From: Waters, David [David.Waters@pgnmail.com]
Sent: Monday, July 02, 2012 4:10 PM
To: Habib, Donald
Subject: Letter 108 Draft RAI Response
Attachments: NRC Letter 108 RAI L-0998 Response - Draft 07-02-12_Part3.pdf

Hearing Identifier: Levy_County_COL_Public
Email Number: 1158

**Levy Nuclear Plant Units 1 and 2
COL Application
Part 2, Final Safety Analysis Report**

Figure 2.5.2-357 Comparison of PBSRS based on updated EPRI-SOG and CEUS SSC models

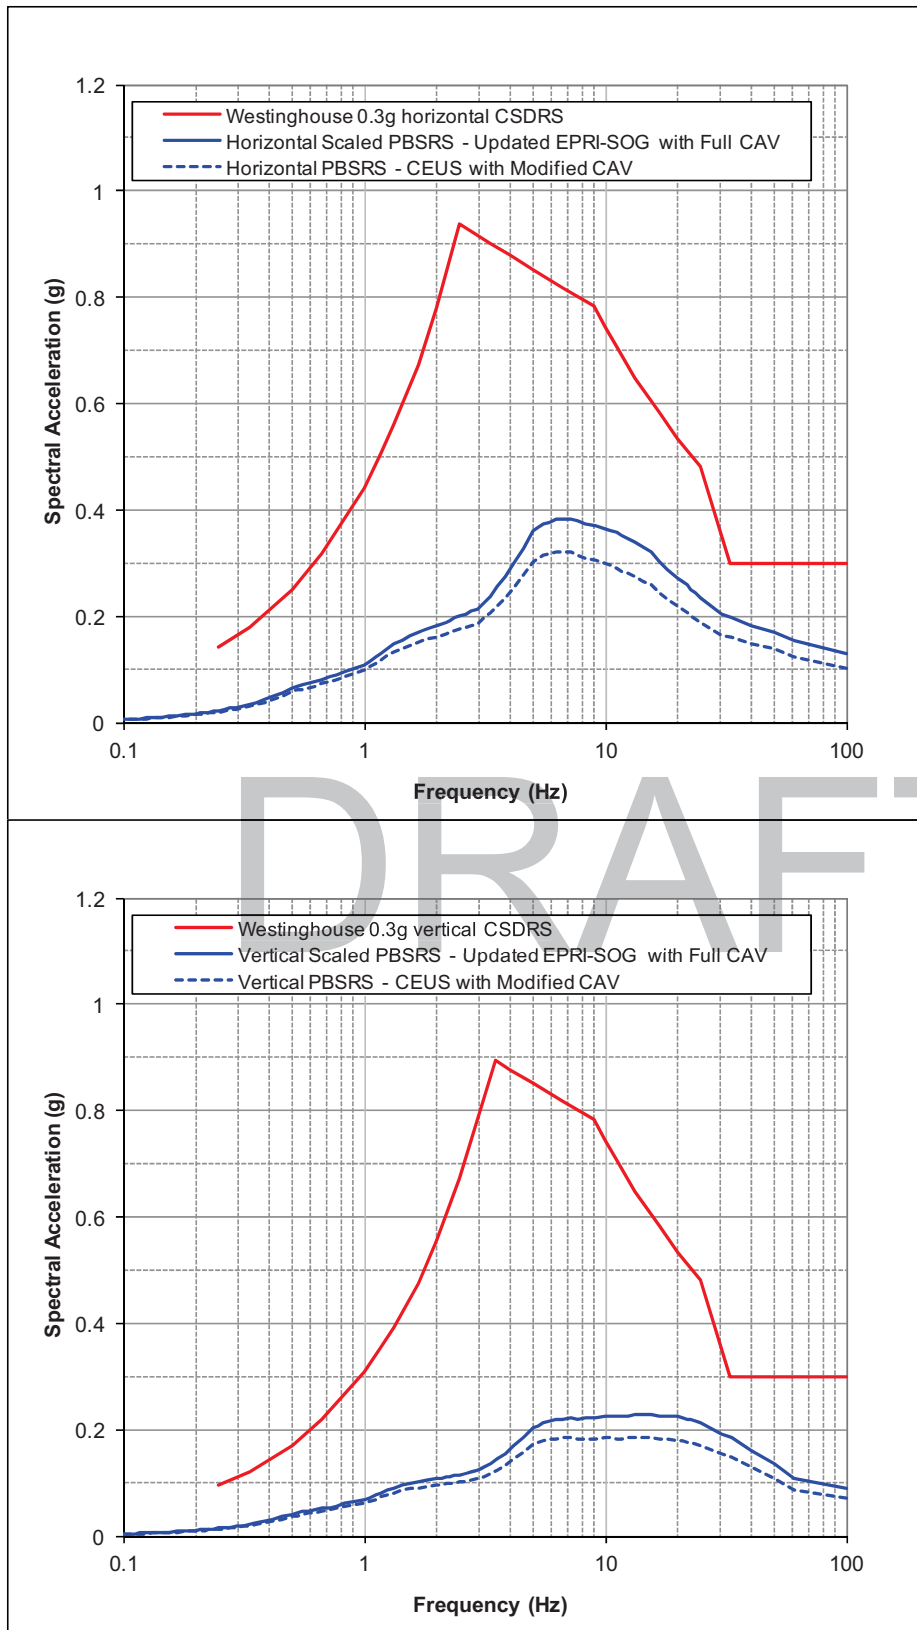
adjacent AB, TB, and RB, earthquake induced cyclic stresses in the soil column were based on ground motions consistent with the finished grade scaled PBSRS. As shown in Figure 2.5.2-357, the CEUS SSC PBSRS is enveloped by the update EPRI SOG scaled PBSRS. Thus, the liquefaction evaluations based on the updated EPRI SOG LNP ground motions bound those from the CEUS SSC ground motions.

As shown in [Figure 2.5.2-357](#), the CEUS SSC PBSRS is enveloped by the updated EPRI SOG scaled PBSRS used for site specific displacement of the Annex Building, Turbine Building, and the Radwaste Building as described in [Subsections 3.7.2.8.1](#), [3.7.2.8.2](#), and [3.7.2.8.3](#). Thus the conclusions in these subsections of no seismic interaction between the Annex Building, Turbine Building, and Radwaste Building and the NI is valid for the LNP site ground motions based on the CEUS SSC model.

Figure 2.5.2-358: Comparison of Reactor Building FIRS based on updated EPRI-SOG and CEUS SSC models

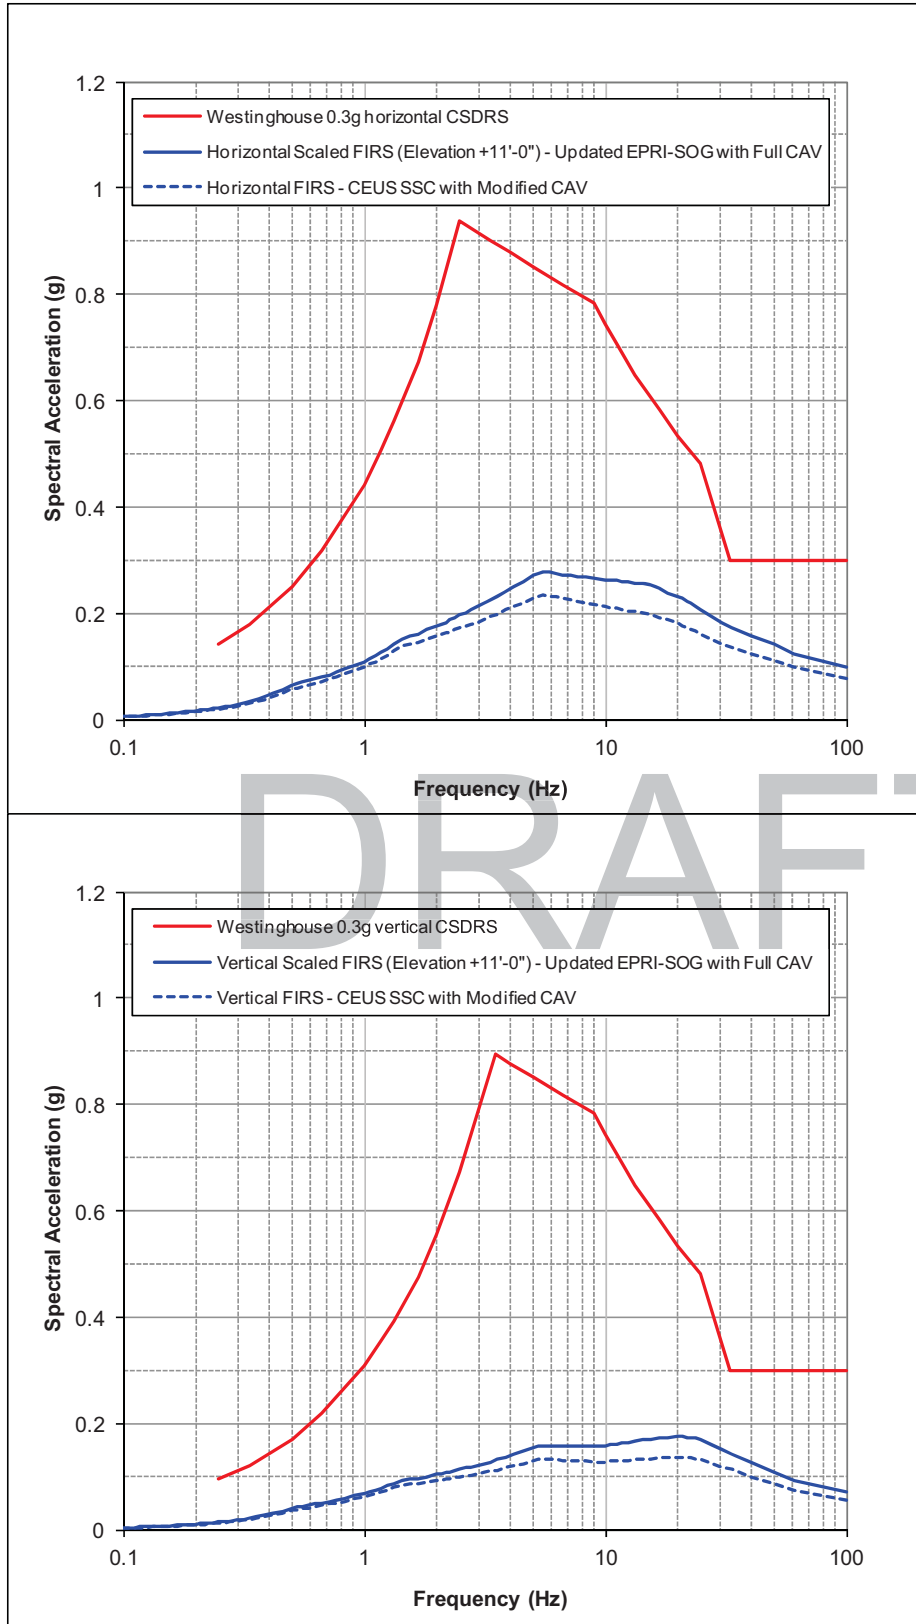
As shown in [Figure 2.5.2-358](#), the CEUS SSC horizontal and vertical FIRS is enveloped by the updated EPRI SOG scaled horizontal and vertical FIRS used for site specific soil structure interaction analysis described in [Subsection 3.7.2.4.1](#). Thus, the conclusions of the soil structure analysis presented in [Subsections 3.7.2.4.1.5](#) and [3.7.2.4.1.6](#) are valid for the LNP site ground motions based on the CEUS SSC model.

Figure 3.7-228

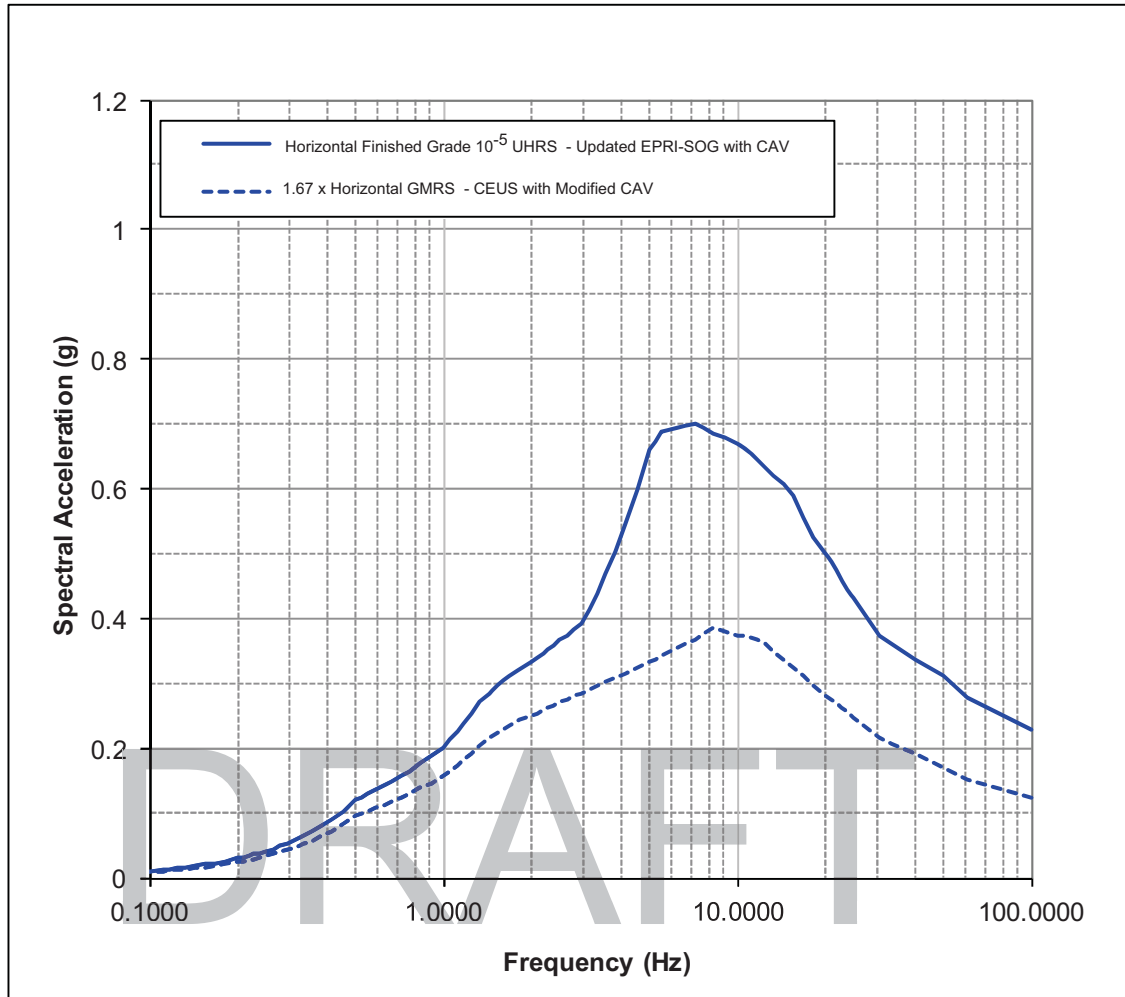
To evaluate the HCLPF liquefaction potential of soils under the adjacent AB, TB, and RB, earthquake induced cyclic stresses in the soil column based on ground motions consistent with the updated EPRI SOG finished grade 10^{-5} UHRS were used. As shown in Figures 3.7-228 and 3.7-229, $1.67*GMRS$ and $1.67*PBSRS$ developed using the CEUS SSC methodology and modified CAV filter are enveloped by the updated EPRI SOG finished grade 10^{-5} UHRS. Thus, HCLPF capacity for no liquefaction potential of soil under the AB, TB, and RB exceeds the $1.67*GMRS$ goal for the plant level HCLPF for the CEUS SSC ground motions.

To evaluate the HCLPF capacity for no seismic interaction between the AB, TB, and RB foundation mats and the NI, the relative displacement between the NI and the AB, TB, and RB foundations was computed based on the updated EPRI SOG 10⁵ UHRS. As shown in Figures 3.7-228 and 3.7-229, 1.67*GMRS and 1.67*PBSRS developed using the CEUS SSC methodology and modified CAV filter are enveloped by the updated EPRI SOG 10⁵ UHRS. Thus, HCLPF capacity for no seismic interaction between the AB, TB, and RB foundation mats and the NI exceeds the 1.67*GMRS goal for the plant level HCLPF for the CEUS SSC ground motions.
